project
SOMMET BLANC - AB
DEER VALLEY, UTAH

A 05/08/25 ASI-012 - JH

FIRE ALARM PLAN -
TOWER A - LVL P2

FA2.2A.02

1 TOWER A - PARKING LEVEL 2A - FA
1/8" = 1'-0"

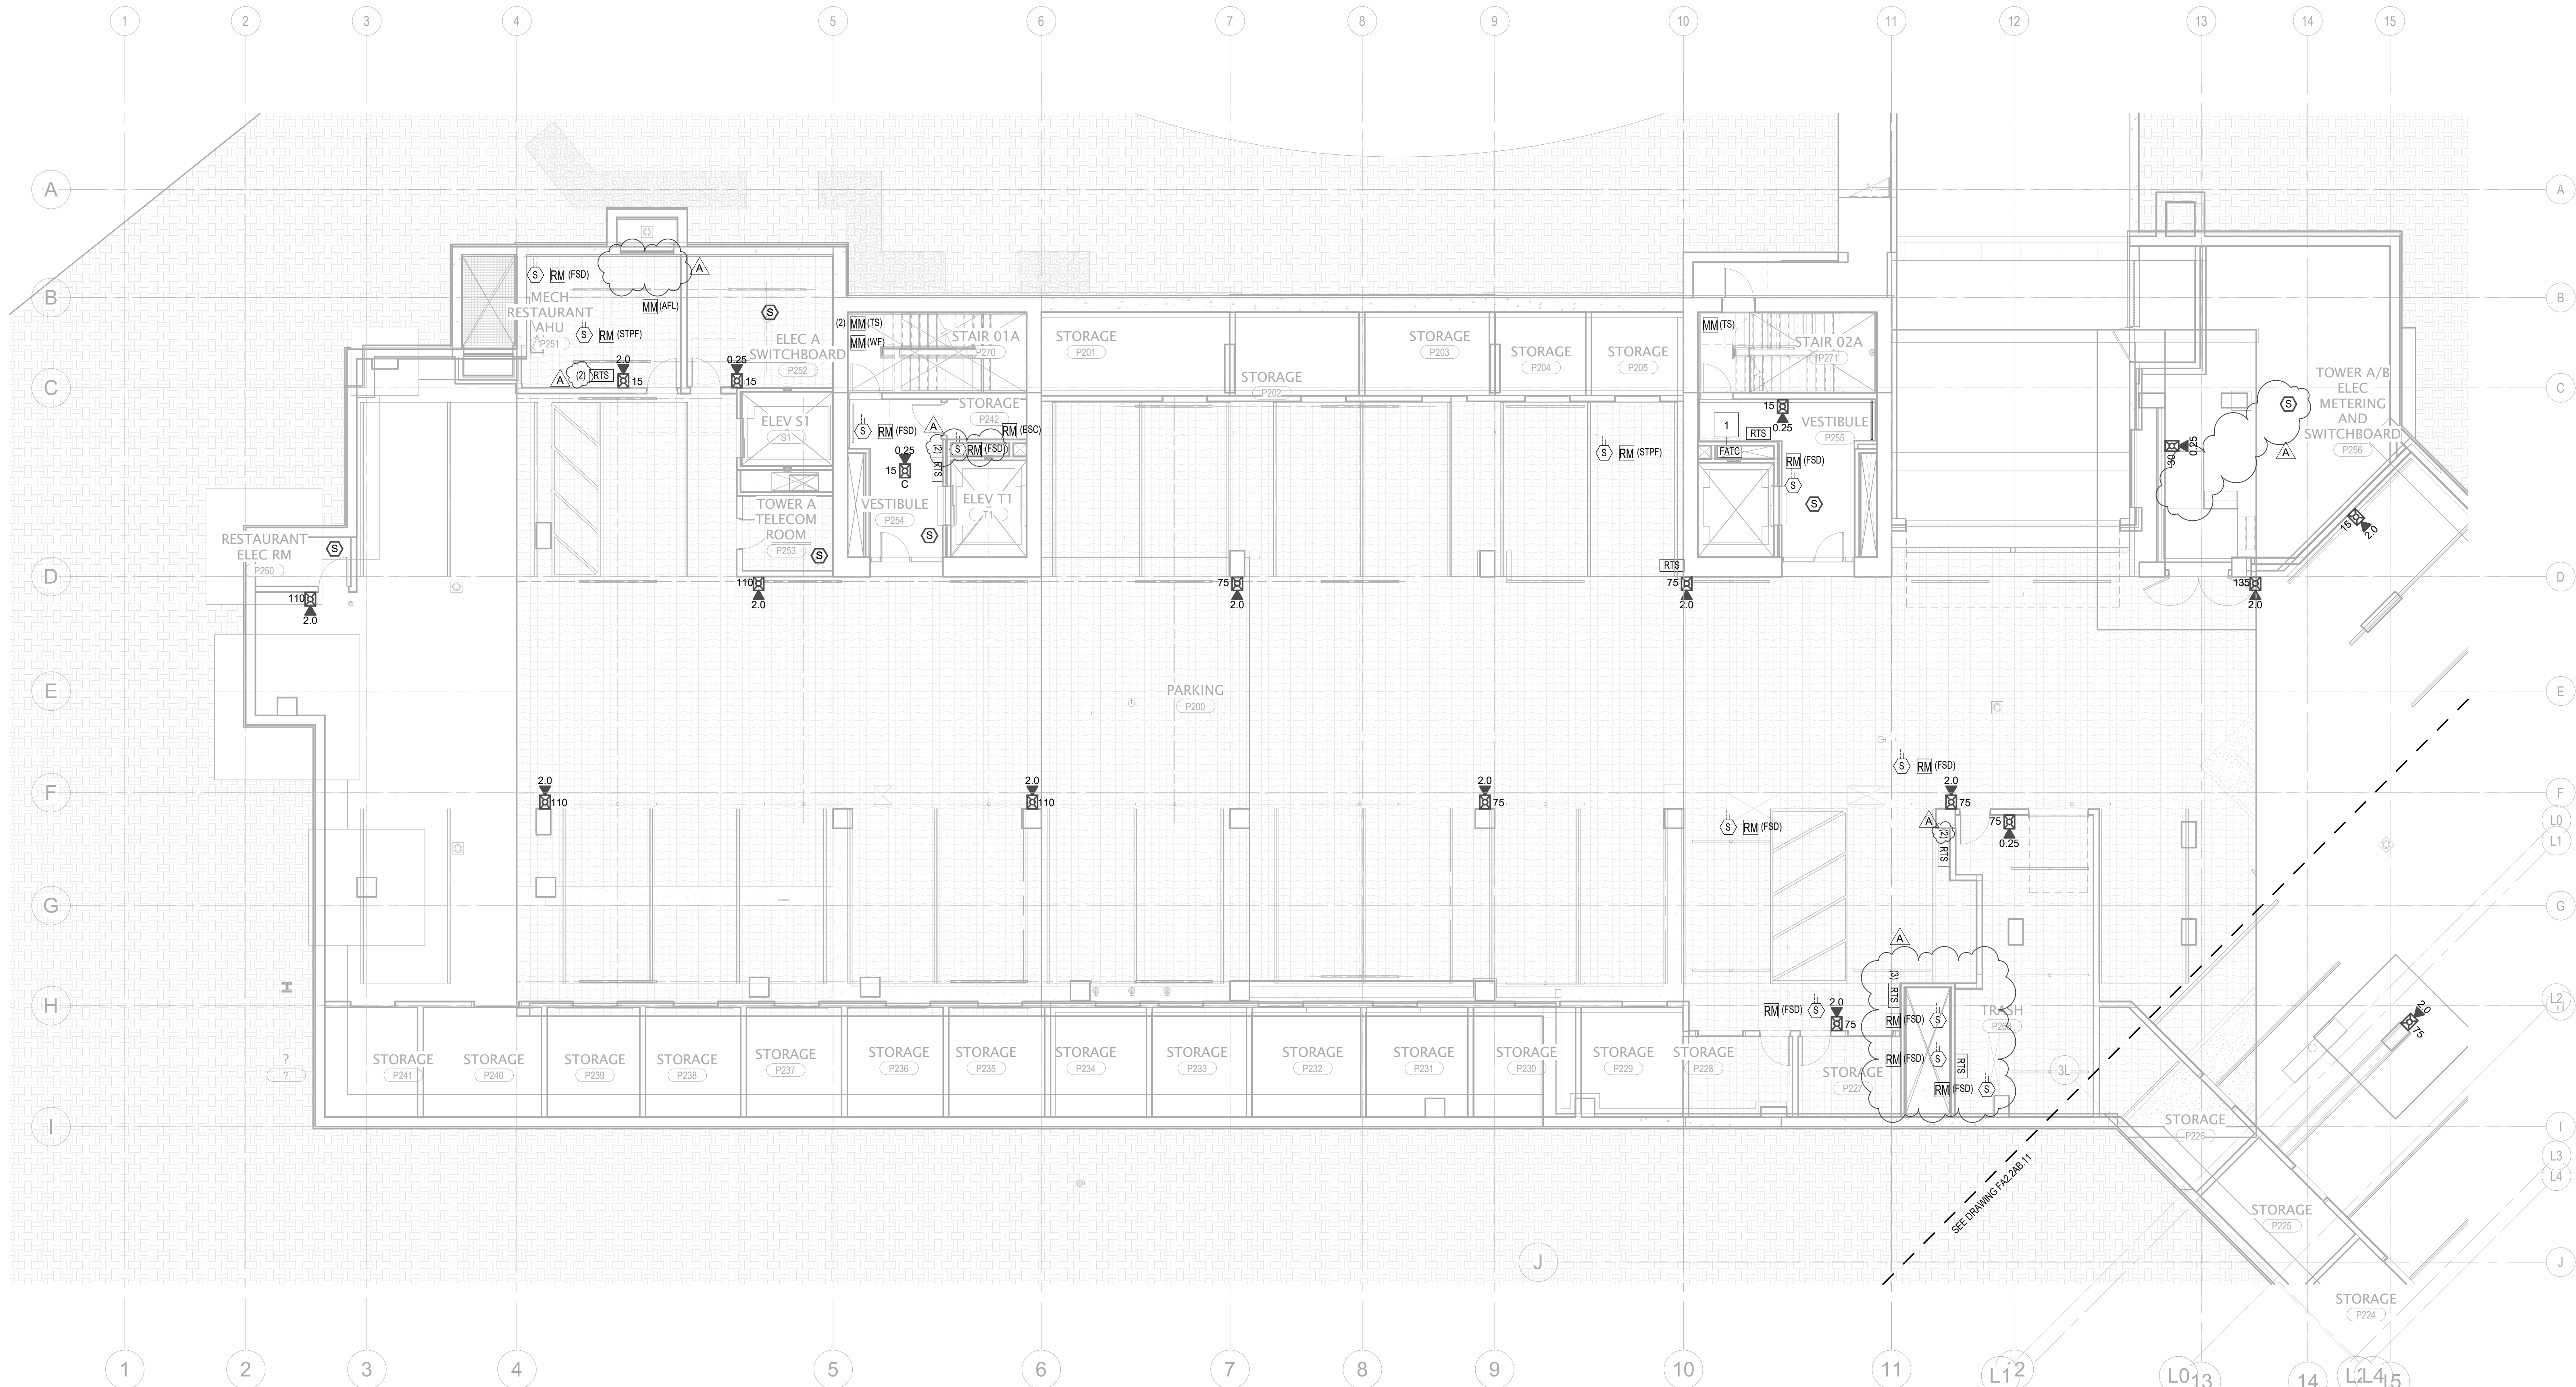
KEYNOTES:
1 FIRE ALARM TERMINAL CABINET WITHIN 2-HR RATED SHUT ACCESSIBLE VIA 2-HR RATED ACCESS PANEL COORDINATE INSTALLATION AND ACCESS WITH DIVISION 26.
